To: Kristopher Byrd, Well Construction Section Manager
From: Tommy Laird, Well Construction Program Coordinator
Subject: Review of Water Right Application G-18852
Date: October 19, 2023

Groundwater Application Review Summary Form

Application # G- 18852

TO: Water Rights Section Date 7/26/2023
 FROM: Groundwater Section Grayson Fish
 Reviewer's Name
 SUBJECT: Application G- 18852 Supersedes review of 6/16/2020
 Date of Review(s)

Well Location Map

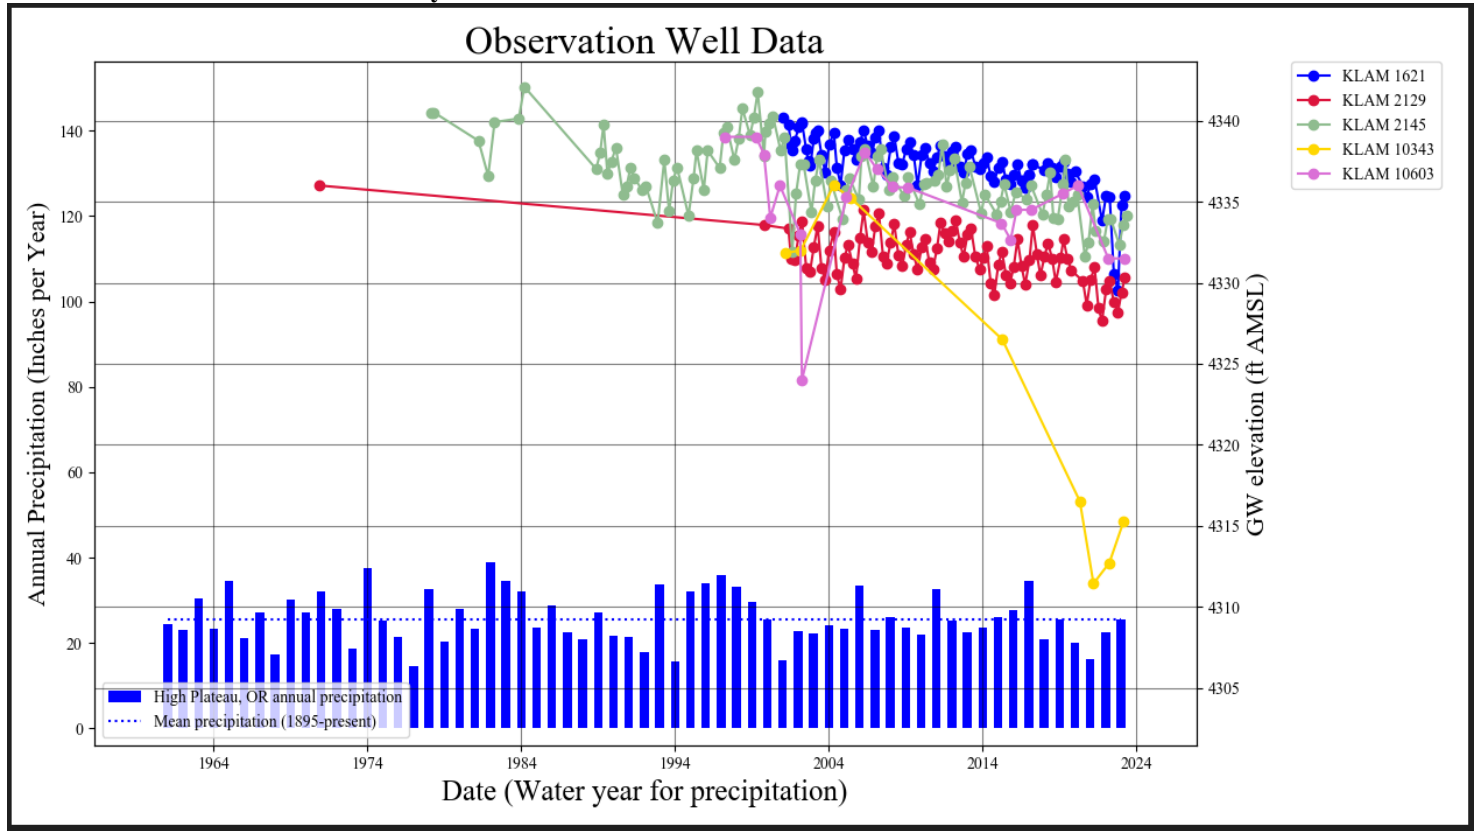
- B3. **Groundwater availability remarks:** The applicants proposed well would develop water from the “crystalline volcanic aquifer that underly the Sprague River valley. There are limited water level data in the vicinity of the applicant’s proposed POA. The closest observation wells **KLAM 1621** and **KLAM 10343** are over 2 miles away in the westerly direction; however, these wells extend into the volcanic rock at depths greater than 300 feet below land surface and groundwater elevations are likely be similar to the proposed well. Similarly, observation wells **KLAM 2129**, **KLAM 10603** and **KLAM 2145** are over six miles to the southeast but have similar groundwater elevations (within 5 feet) as **KLAM 1621** and **KLAM 10343**. In general, the hydrographs follow climatic trends with approximately 5 feet of decline over the period of record. The hydrograph of **KLAM 10343** shows similar groundwater elevations as the other wells considered through 2005. However, between 2005 and 2023, groundwater elevation in **KLAM 10343** declined approximately 20 feet. The groundwater declines observed in **KLAM 10343** do appear to be anomalous compared to other wells in this portion of the Sprague River Valley. Available groundwater level data in the noted wells do not display excessive declines or excessively declining trends, therefore there is not a preponderance of evidence that groundwater of the target aquifer is over appropriated. Similarly, there is not a preponderance of evidence that the proposed use would not be within the capacity of the resource and so conditions in B1(d) are recommended.

There is one permitted groundwater right that is located approx. 1400 ft from the proposed POA. Given the nature of the aquifer system in the area (high-transmissivity, high-yield) and the depth of the nearby permitted well (312 ft with 150 ft SWL), it is unlikely that the applicant’s use of 0.25 cfs would produce enough hydrologic interference to result in injury to this, or other, permitted water rights. However, standard interference conditions should be applied.

Hunt (2003) transient stream depletion model

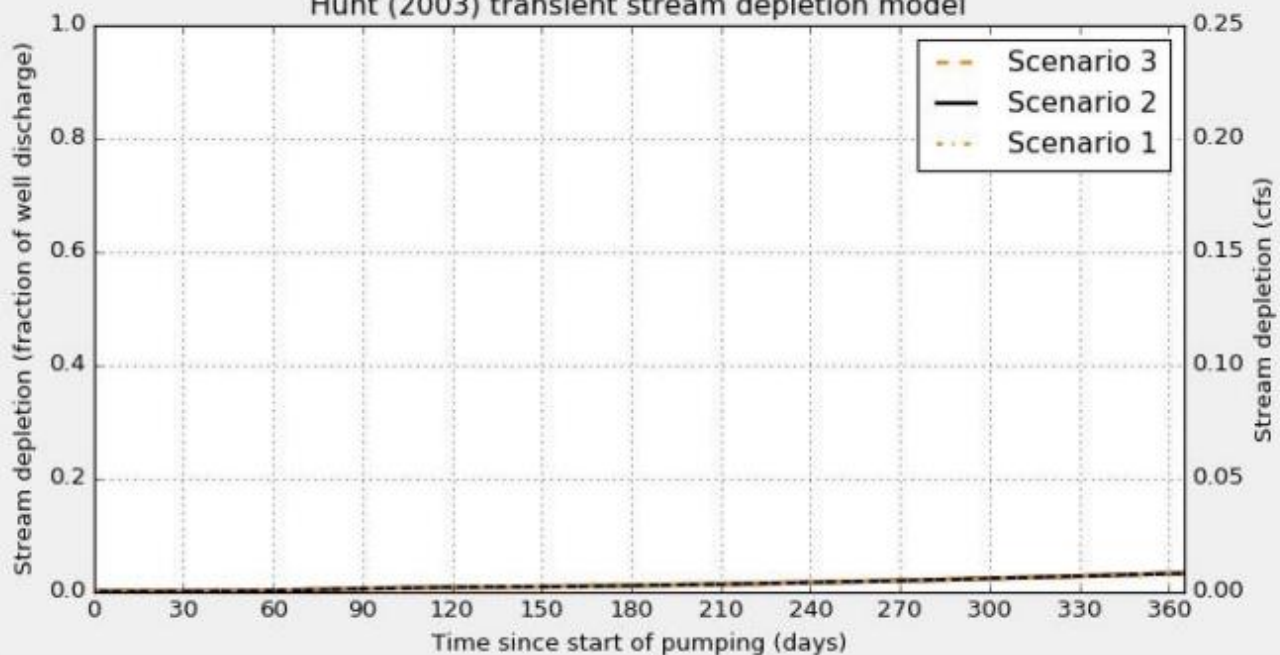
Basis for impact evaluation: Stream-depletion was estimated to Snake Creek using the Hunt (2003) stream-depletion model with parameter values informed by Gannett et al. (2021) and using methods previously used by the Department for estimating stream-depletion in the Klamath Basin. The main control on stream-depletion for this application is the distance to the nearest, hydraulically-connected stream reach, which is based on assumed static water levels and on proposed construction. Stream-depletion estimates are assumed to be different if the well is not constructed as proposed.

C6. **SW / GW Remarks and Conditions:** The applicant's proposed POAs would be producing from an aquifer that has been found to be hydraulically connected to surface water – specifically Snake Creek and the Sprague river- at distances of just over 3 miles. Stream-depletion was estimated using standard practices of the Department and the proposed rate and level of impact does not reach the level where PSI is assumed.
